ADDENDUM NO. 11

March 21, 2022

THE CITY OF SPARTANBURG, SOUTH CAROLINA
SPARTANBURG FIRE STATION ONE
450 Wofford Street, Spartanburg, SC 29301
Architect's Project No. 1599

BID QUESTIONS & ANSWERS (Red are the Answers & Blue are the new Architectural Clarifications)

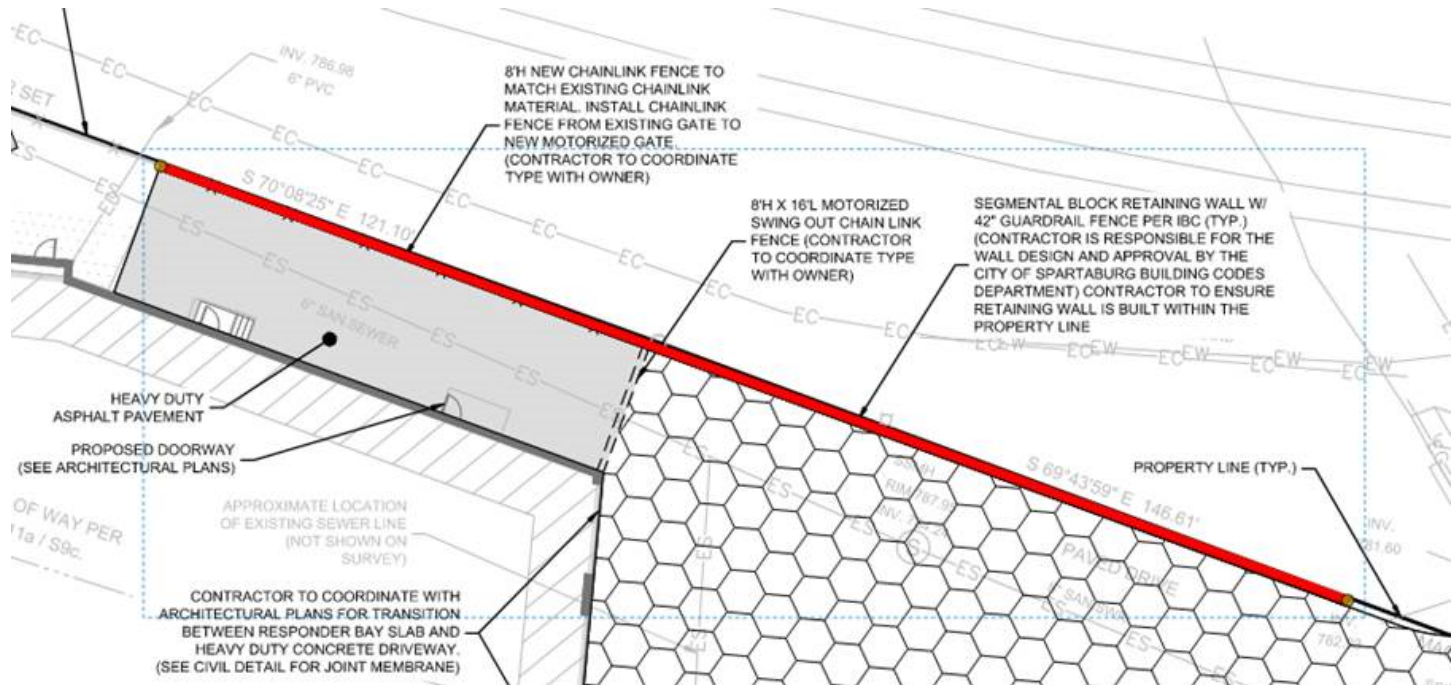
2. Reference Door & Frame Schedule, please advise material of the F12 & F2 door frames. Aluminum or Hollow Metal? *There's no F12, but F1 & F2 will be aluminum frame for the non-rated interior doors, color & profile to match existing (shown in that picture). But for all the rated interior doors, use rated Hollow Metal Frame then paint to match aluminum frame color. For all exterior doors, use Hollow Metal Frame (see attached updated sheet 4.70).*

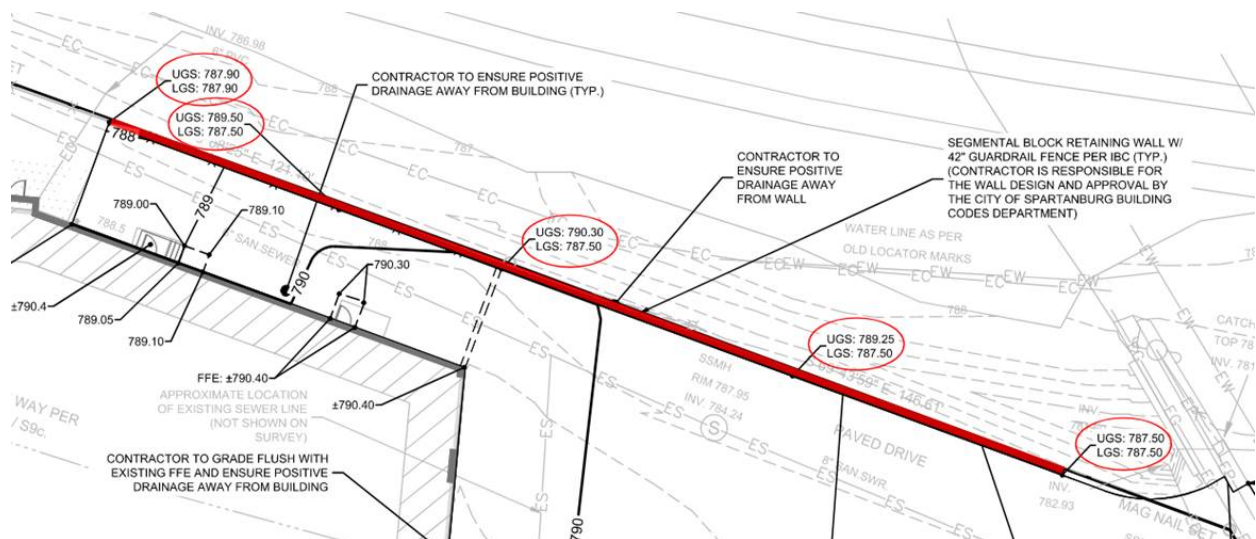
1. Reference Sheet C5.0 - It is not clear on the length of the retaining wall here, please advise on where this wall is intended to start and stop. *Please see image below for wall limits. The wall is approximately 195 linear feet (LF) in length.*
